Work Order ID 134447

Item Name: Plate

DRAWING NO. D3592	TITLE PLATE	REV. B	DART AEROSPACE LTD ENGINEERING ORDER		D.E.O. NO. D3592-B-1	SHEET NO. SHEET 1 OF 1	SCALE NTS
DRAWN AJS	CHECKED b	MFG. APPR. AA	APPROVED MP		DE APPR. MP		
DATE 08.09.11	DATE 08.09.11	DATE 08/09/11	DATE 08/09/11		DATE 08/09/11

DESIGN <i>qp</i>	DRAWN BY <i>DC</i>	DART AEROSPACE LTD HAWKESBURY, ONTARIO, CANADA	
CHECKED <i>qp</i>	APPROVED <i>[Signature]</i>	DRAWING NO. D3592	REV. B SHEET 1 OF 1
DATE 07.05.31		TITLE PLATE	SCALE 1:1
A	07.01.15	NEW ISSUE	
B	07.05.31	TOOLING HOLES ADDED

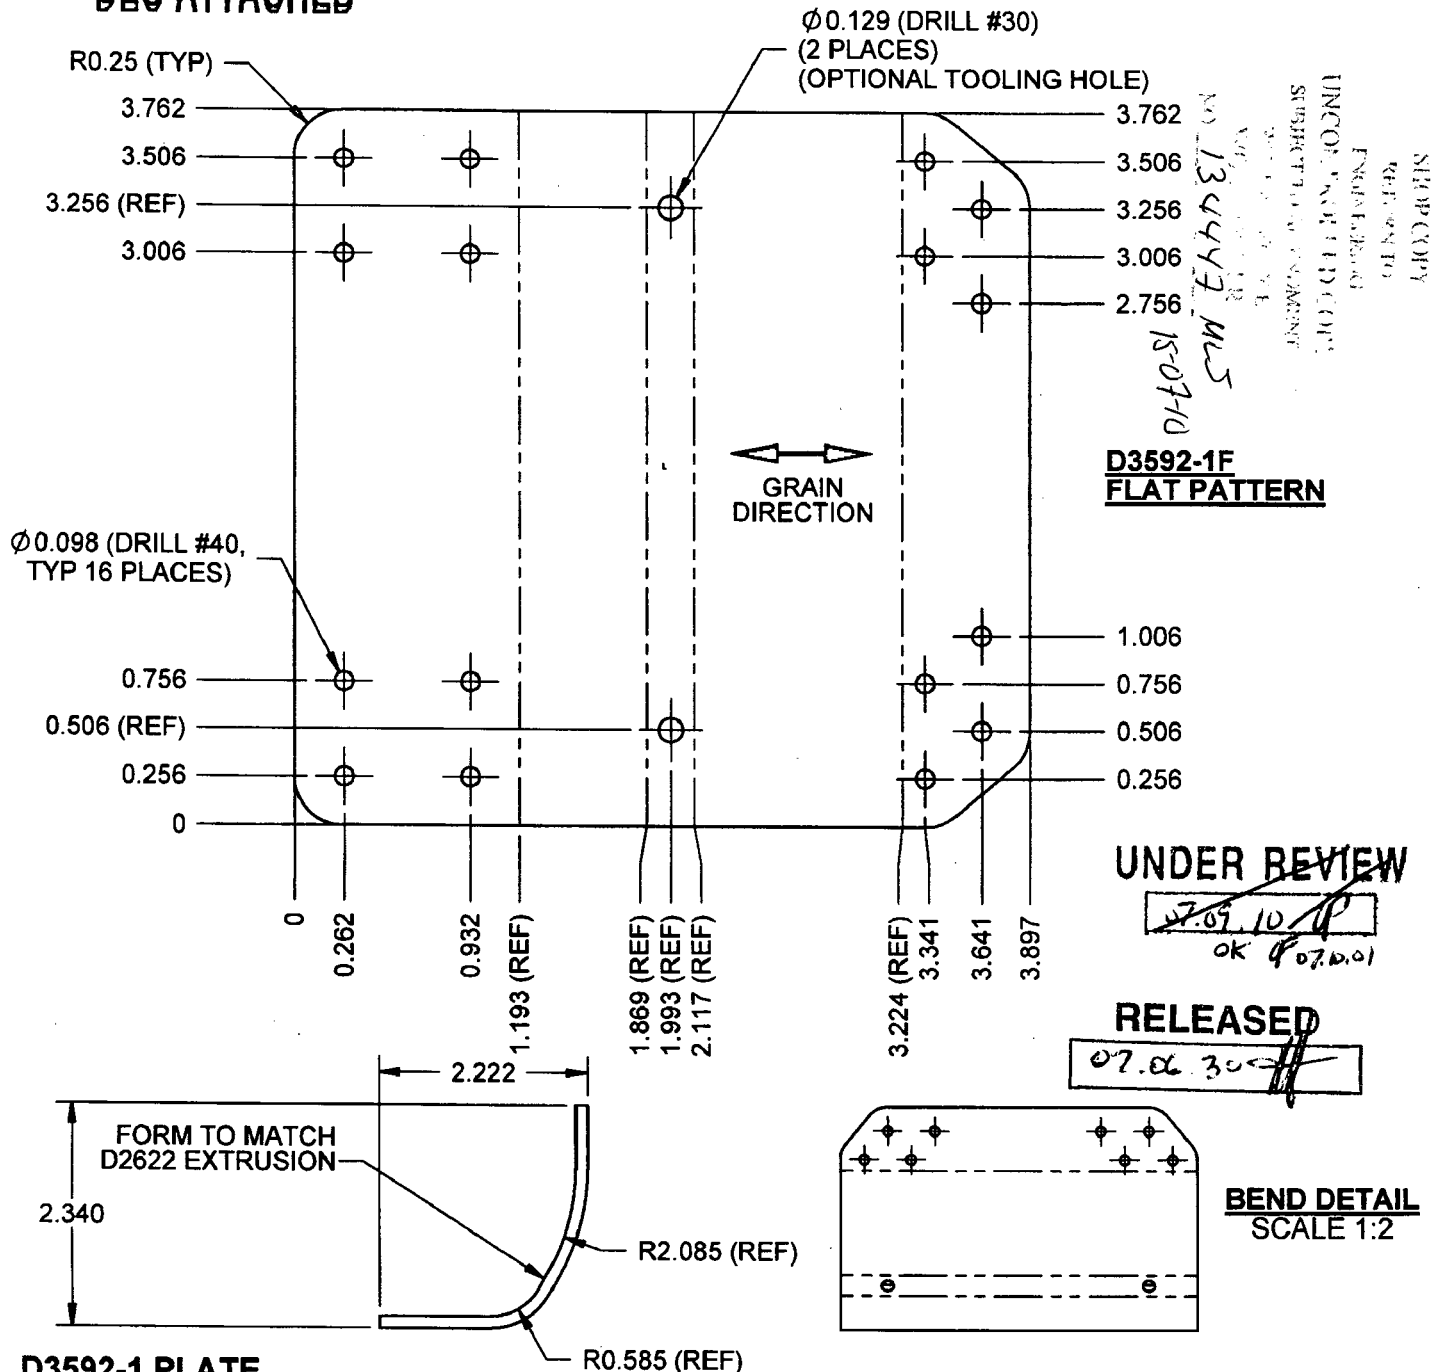
DEO ATTACHED

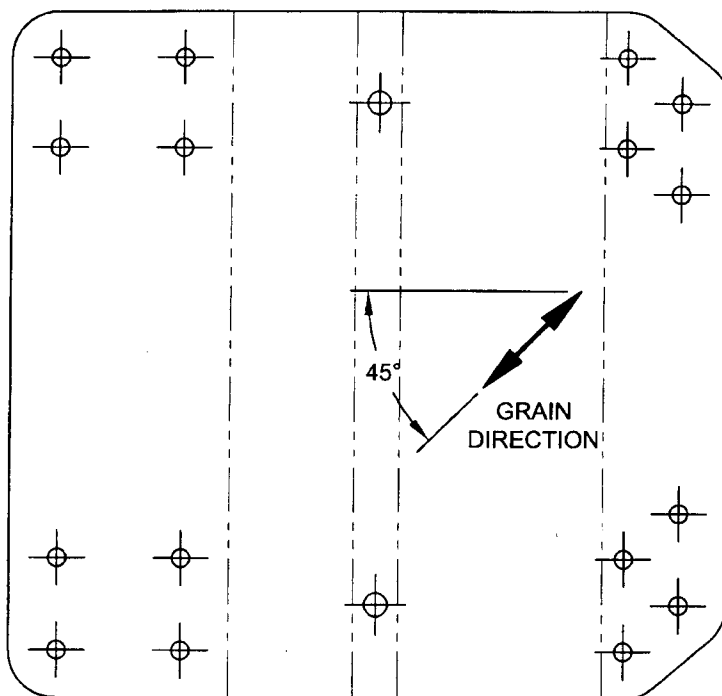
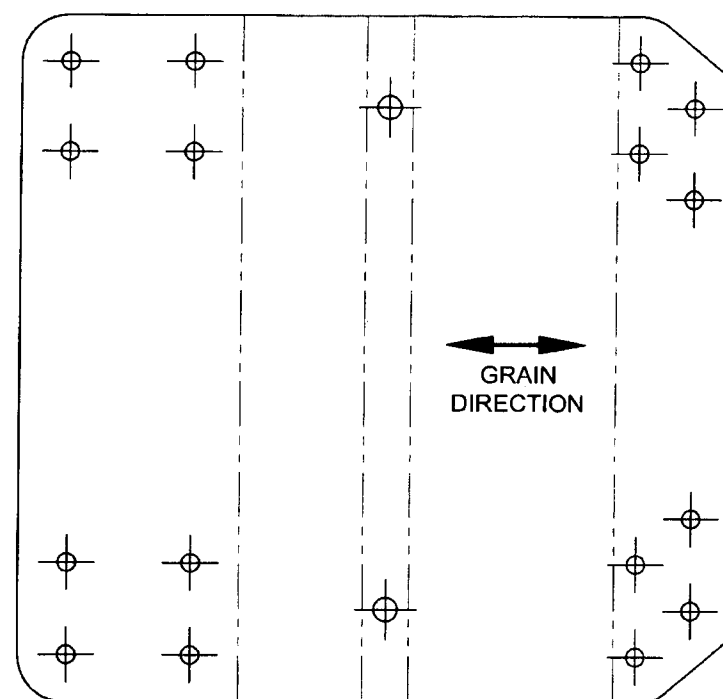
MODIFY GRAIN DIRECTION AS SHOWN BELOW TO PREVENT CRACKING WHEN WELDING AT ASSEMBLY (SEE CAR 08-026).

IS:

WAS:

ALL OTHER INFORMATION REMAINS UNCHANGED
